# Memorandum

**Subject:** THP No. 1-04-115 SCR  
Hydrologic Review

**Date:** July 29, 2004

Figure 1. Air photo view of the Felice THP area and the site reviewed in the field on July 27, 2004 (prepared by Mr. Rich Sampson, CDF, San Mateo-Santa Cruz Unit).

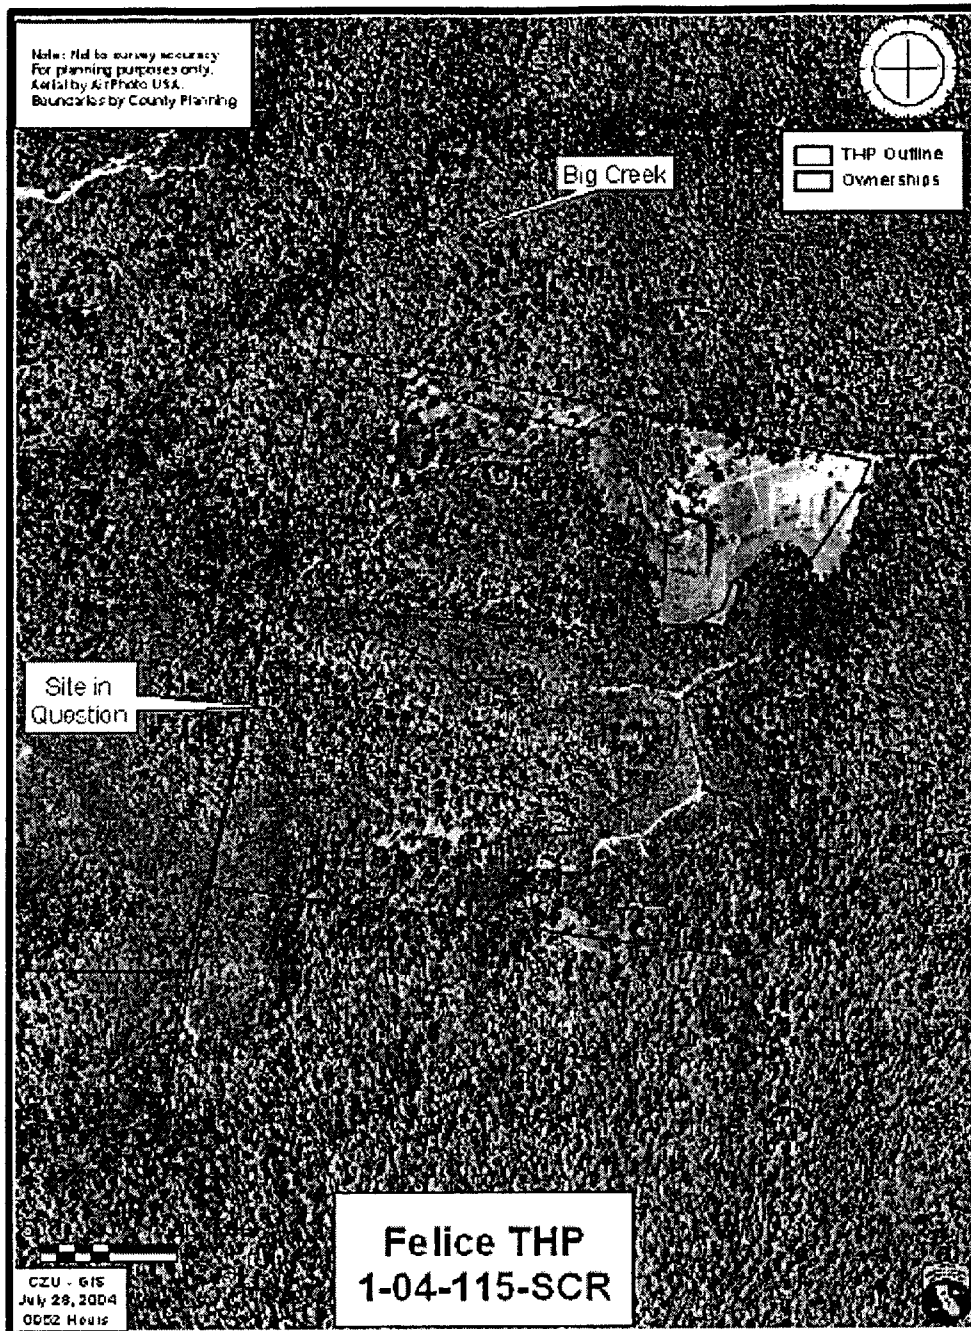
I was asked to: 1) review the portion of a Class II watercourse from watercourse crossing "i" down to the property boundary, a distance of approximately 800 feet, 2) determine if the area adjacent to the channel should be considered part of the channel zone, as defined by the Forest Practice Rules (FPRs), and 3) help determine appropriate protection measures for this Class II watercourse to meet the requirements of the FPRs (Figure 1).
